POLICY REPORT

Report Date: January 2, 2019
Contact: Karen Hoesse
Contact No.: 604.871.6403
RTS No.: 12856
VanRIMS No.: 08-2000-20
Meeting Date: January 15, 2019

TO: Vancouver City Council
FROM: General Manager of Planning, Urban Design and Sustainability
SUBJECT: CD-1 Rezoning: 1906-1918 West 4th Avenue

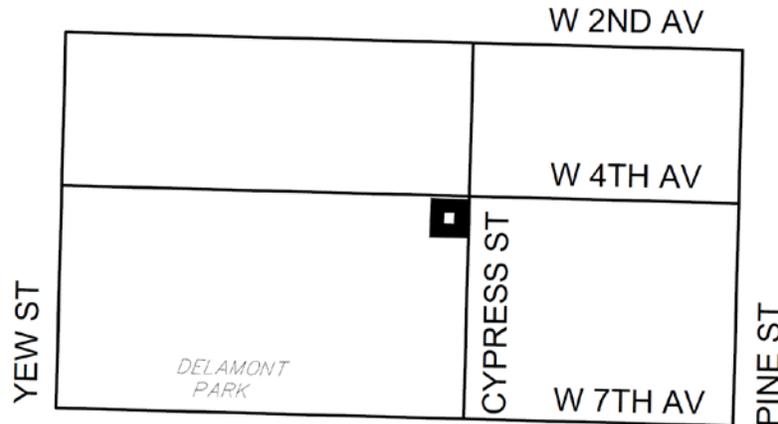
Additional suggestions included to connect both the indoor and outdoor and use the amenity space as a way to transition. There were divided opinions on the saw tooth in regards to the public realm.

Opinions included West 4th does not have a saw tooth typology on the ground plain, therefore anything that can be done to free up space would be beneficial. Additional comments included the blank wall at the bike room would benefit from some daylight space and a window. There is a wall to the pad-mounted transformer that will be visible as you are coming around the corner on the lane. More consideration to how this wall will function. The balconies appear rigid and repetitive.

Applicant's Response: The applicant team thanked the panel for their comments.
